UNITED STATES PATENT AND TRADEMARK OFFICE

APPLICATION NO.	FILING DATE	FIRST NAMED INVENTOR	ATTORNEY DOCKET NO.	CONFIRMATION NO.
10/815,685	04/02/2004	Frederic Magneron	Q80876	9408

Office Action Summary

DETAILED ACTION

【図2】

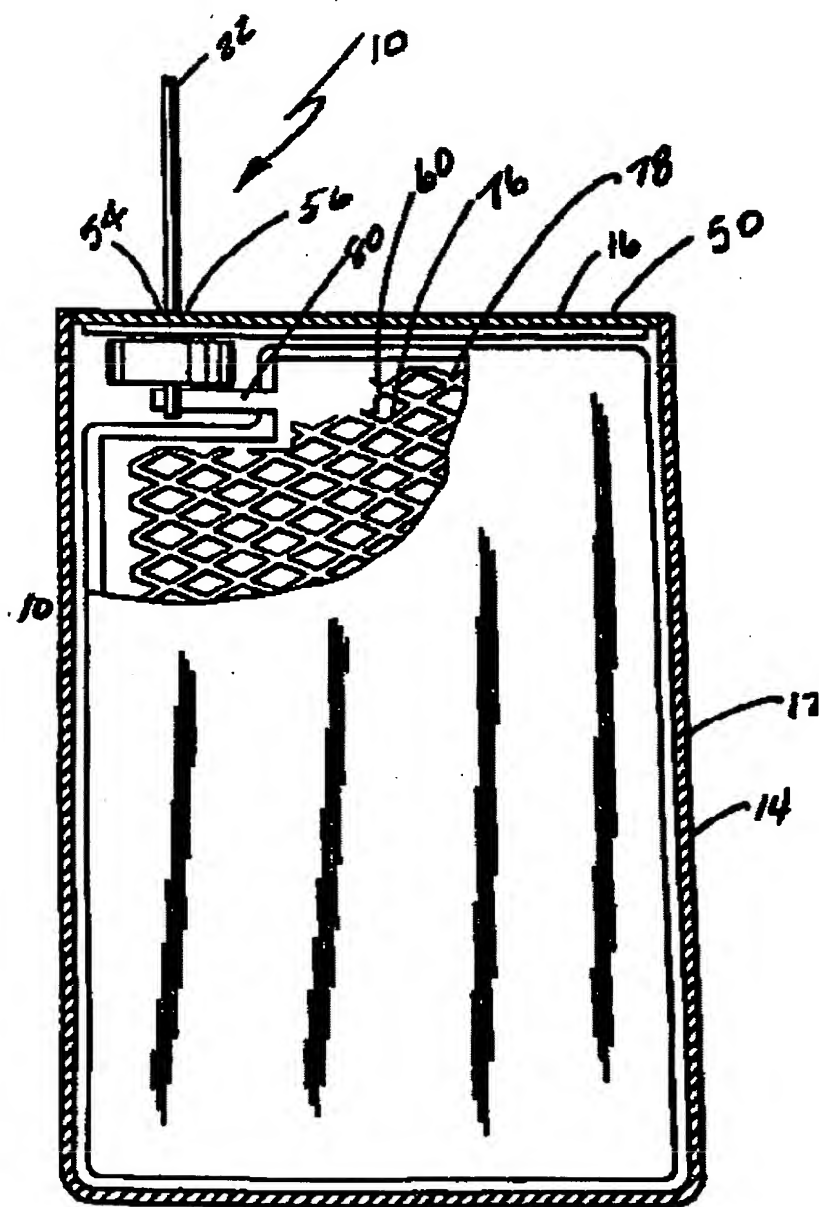
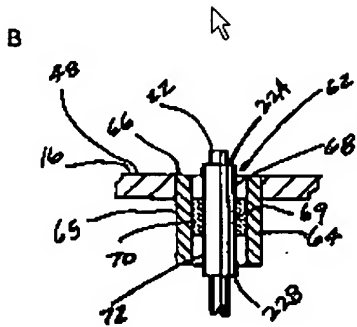
5. Claims 1-4 are rejected under 35 U.S.C. 102(b) as being anticipated by JP A 2002-373641 (JP '641).

JP '641 discloses a system for electric coupling of a plane connection 80 on a current output terminal comprising a tubular conducting slug 22, wherein said connection 80 comprises a hole and in that said connection is fixed on a transversal section of said slug 22 in such a manner as to cause this hole to electrically communicate with the inside of said tube (Figs. 2 applied to claims 1 and 3). The

connection is welded to said slug (applied to claim 2). In one embodiment, the slug is provided with an outer sleeve 69 and inner separate portion 22 (see Figs. 3, 4 and 6) wherein the extended portion 22 would be the part in electrical communication with the lead from the electrochemical cell. Thus in employing the sleeved terminal in the lower figure into the battery of Fig. 2, the inner portion 22 would be the portion which would communicate with the opening in the lead 80 (as applied to claims 1 and 3). The arrangement in the lower figure includes a surrounding annular glass seal 69 (as applied to claim 4).

【 1】

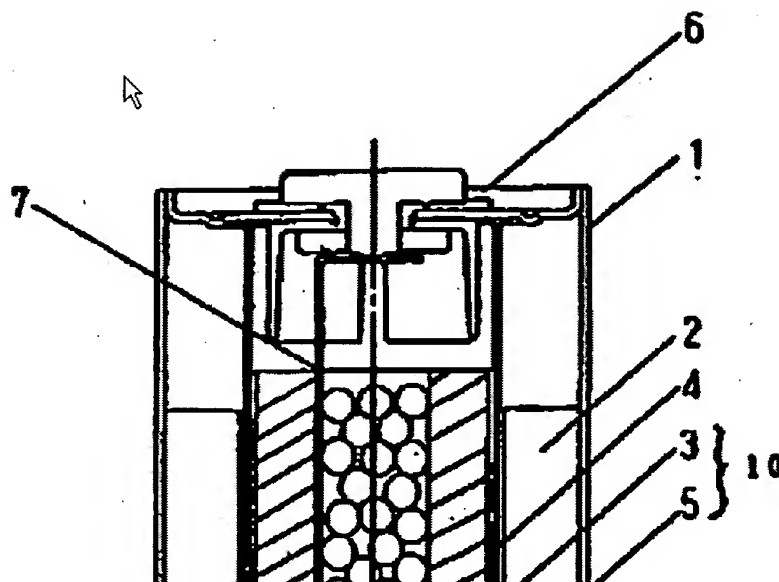
6. Claims 1 and 2 are rejected under 35 U.S.C. 102(b) as being anticipated by JP 09-153368 A (JP '368).

JP '368 discloses a system for electric coupling of a plane connection 7 on a current output terminal comprising a tubular conducting slug, wherein said connection 7 comprises a hole and in that said connection is fixed on a transversal section of said slug in such a manner as to cause this hole to communicate with the inside of said tube (Fig. 1 below applied to claim 1). The connection 7 is welded to said slug (as applied to claim 2).
